# SERVICE *No.* 923 BULLETIN

Date August 16, 1989 M

Main Landing Gear Actuator  
Reinforcement Bracket Replacement

Sketch "A"

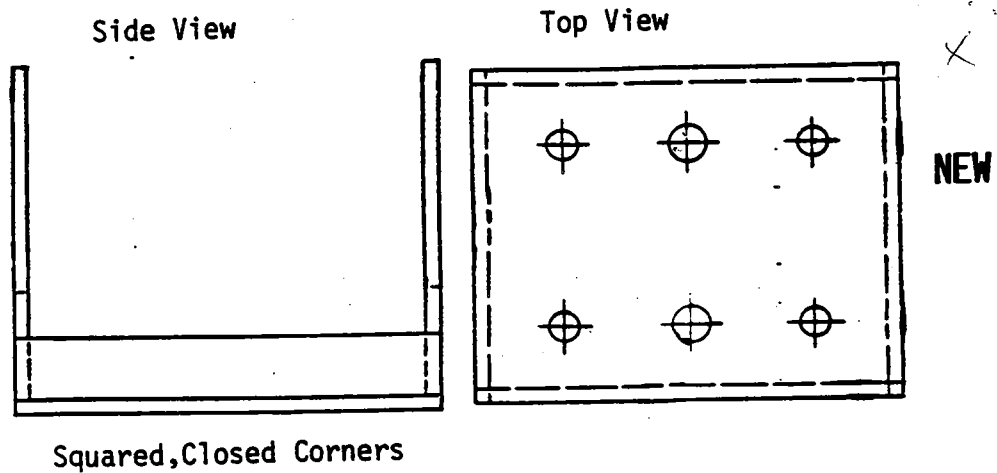
Some aircraft may have the new actuator reinforcement brackets (Piper Part Number 73786-02) installed as replacement parts. Refer to Sketch "A" for identification of Piper Part Numbers 40776-00 (old) and 73786-02 (new). Aircraft with Piper Part Number 73786-02 installed on both sides are in compliance with this Service Bulletin.

1. Place aircraft on jacks.
2. Locate the main landing gear actuator reinforcement bracket on the left and right wings. See Sketch "B" (attached).
3. Remove and discard original Actuator Reinforcement Brackets, Piper Part Number 40776-00. Install Piper Part Number 73786-02, as shown in Sketch "C".
4. Inspect and perform gear retraction per appropriate Chapter in the Maintenance Manual.
5. Remove aircraft from jacks.
6. Make appropriate logbook entry of compliance with this Service Bulletin.
